UNITED STATES PATENT AND TRADEMARK OFFICE

APPLICATION NO.	FILING DATE	FIRST NAMED INVENTOR	ATTORNEY DOCKET NO.	CONFIRMATION NO.
10/707,365	12/09/2003	Kenneth Boyd	81044284	1364
77327	7590	12/09/2008	EXAMINER	
ANGELA M. BRUNETTI, PLLC 11300 E. CARIBBEAN LN. SCOTTSDALE, AZ 85255				JONES, HUGH M
ART UNIT		PAPER NUMBER		
2128				
MAIL DATE		DELIVERY MODE		
12/09/2008		PAPER

Office Action Summary	Application No.	Applicant(s)	
	10/707,365	BOYD ET AL.	
	Examiner	Art Unit	
	Hugh Jones	2128

DETAILED ACTION

Fig 1

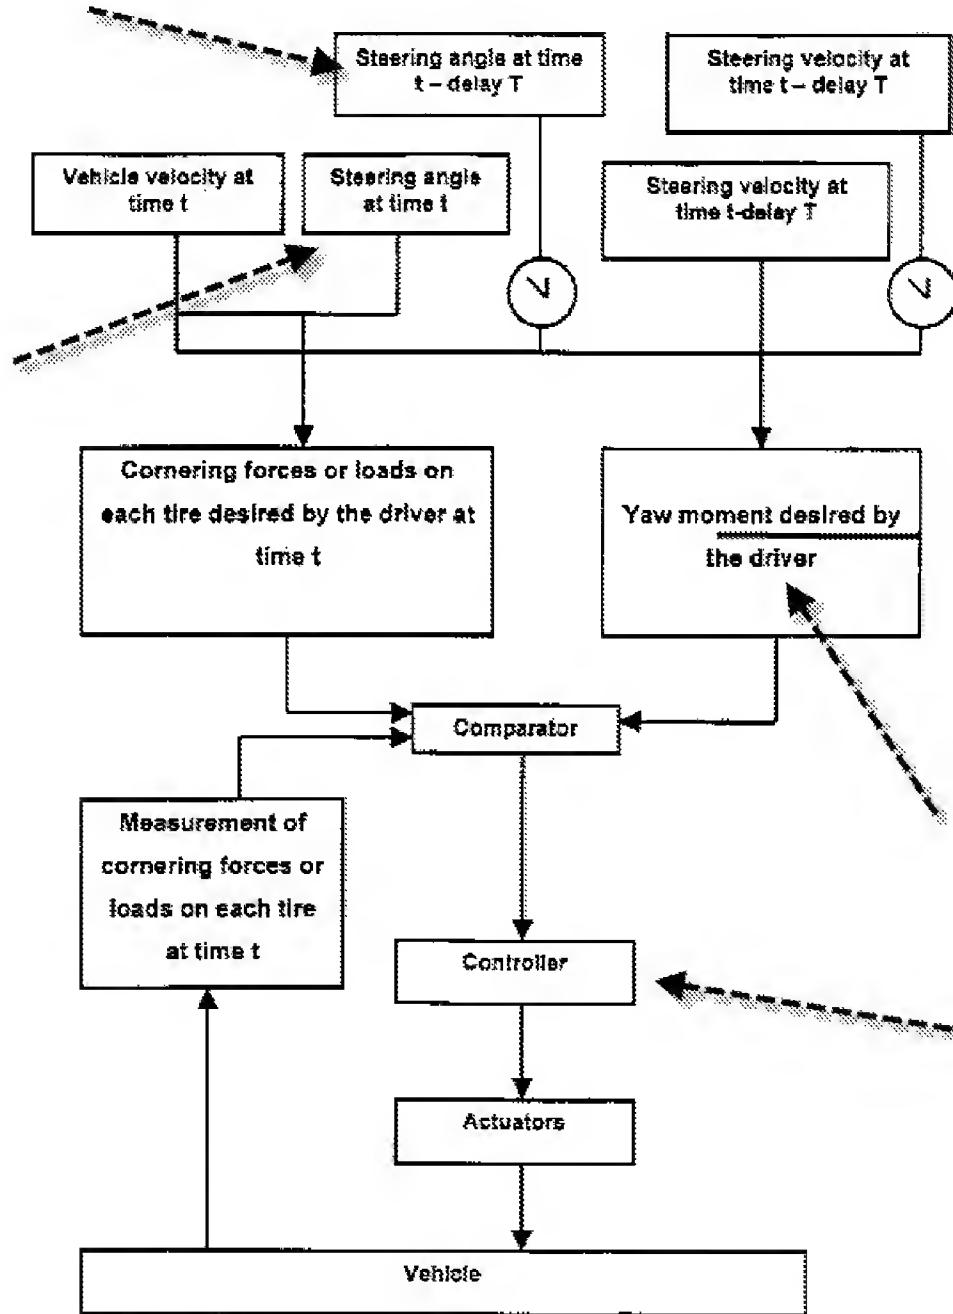
6. Pallot discloses control, modeling and simulation of over- and understeering including initial and subsequent wheel angles, “look ahead” for the driver, and which is continuously updated over time. See fig. 1, and corresponding text (col. 10, line 3 to col.

16, line 33. Simulations are described on col. 16, line 37 to col. 18, line 53. The system in fig. 1 is called a “simulation” system; however, it functionally produces the same results (hence the 103).

Figure 11

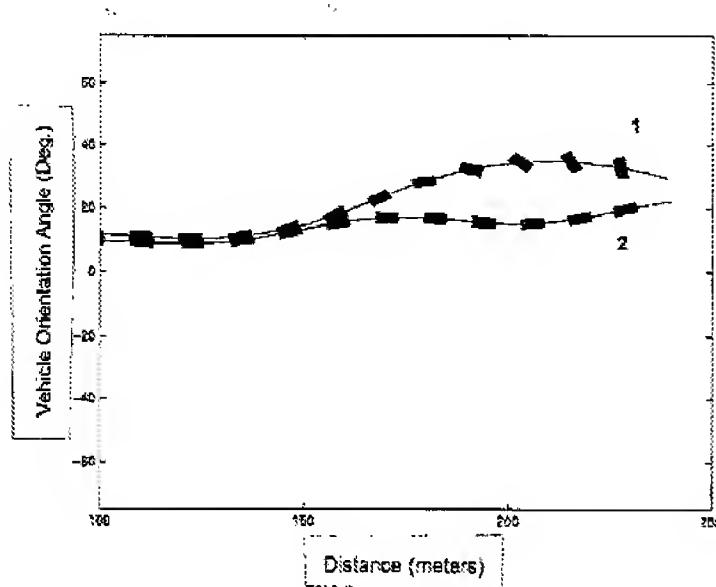
Note fig. 11:

In the second simulation (FIGS. 8a-c, 9a-d, 10a-d, 11 and 12) it is shown how a modification of the front/rear anti-rolling distribution, controlled as explained above, enables the path of the vehicle to be stabilized. The maneuver is identical to the previous maneuver (steering command in the form of an increasing sinusoidal curve on a wet surface at 90 km/h). As soon as excessive yaw forces are detected, the anti-rolling device is reinforced at the front of the vehicle and is reduced by the same amount at the rear so as to make the vehicle stable as quickly as possible and to utilize in the best possible way the gripping potential of the four tires. The saturation of the cornering forces is better controlled and permits smaller phase differences, which means that yaw moments are better handled and vehicle body changes are more readily identified. To reiterate, in each case the reference "A" represents the actual forces (continuous curve) and the reference "D" refers to the instruction expressed by the proposed method (dotted curve).

Fig. 1

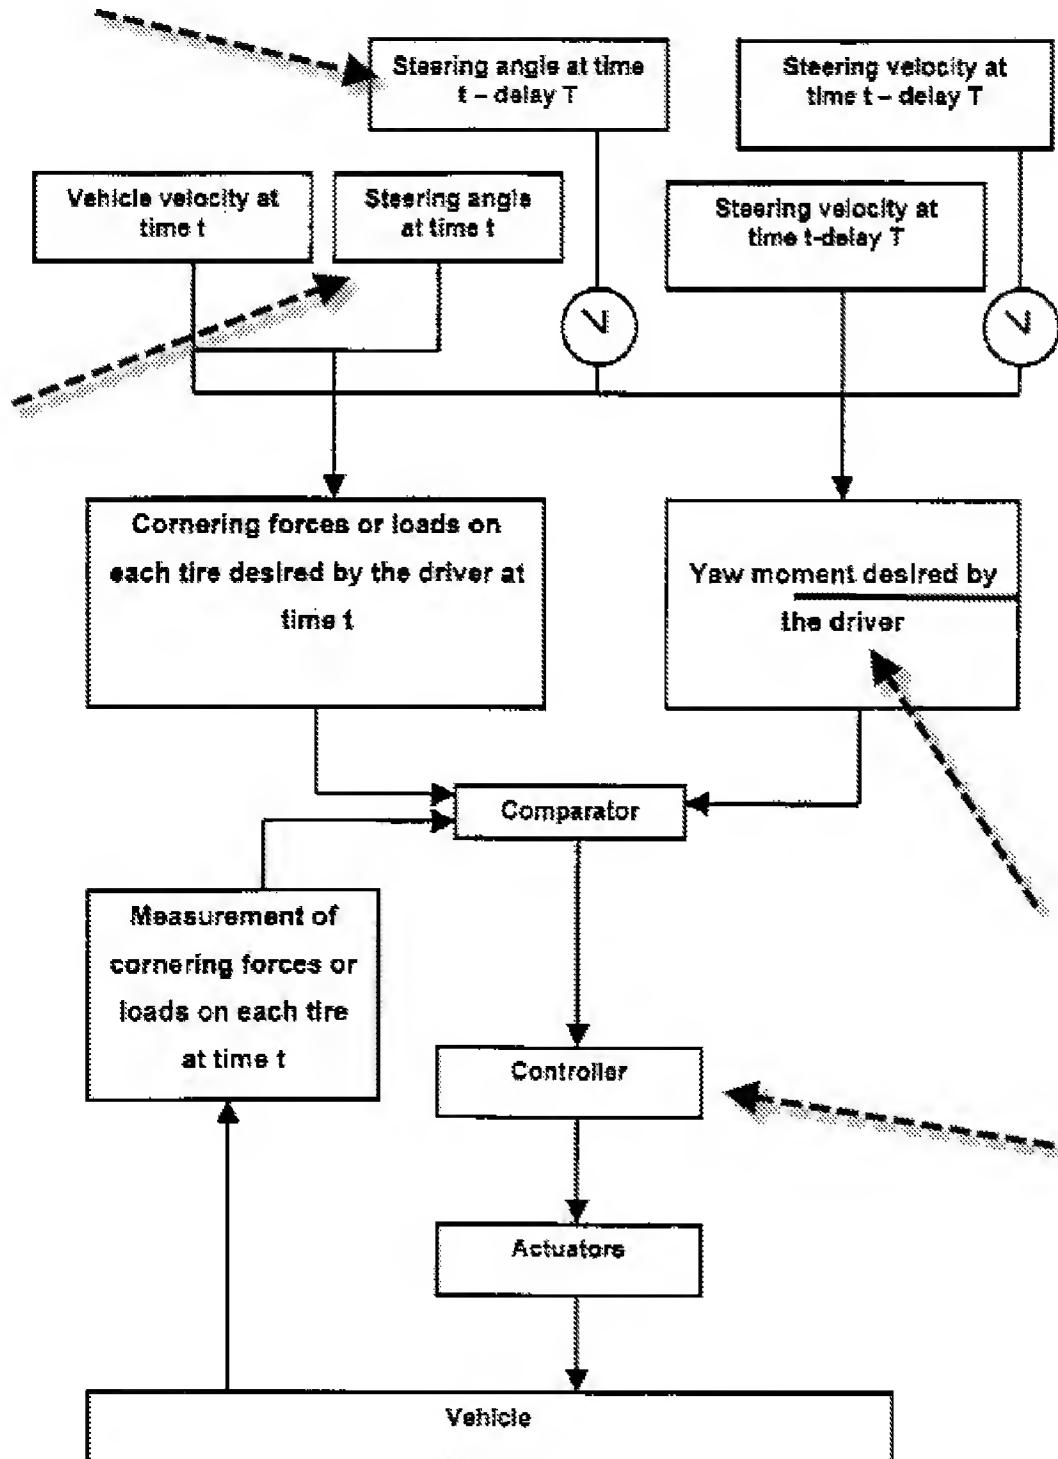
Pallot discloses (col. 8, lines 35 to col. 9, line 8 that tires reaching 'saturation' cause over and under-steering (depending upon whether the front or rear tires become saturated) and discloses a corrective mechanism (fig. 1) to compensate:
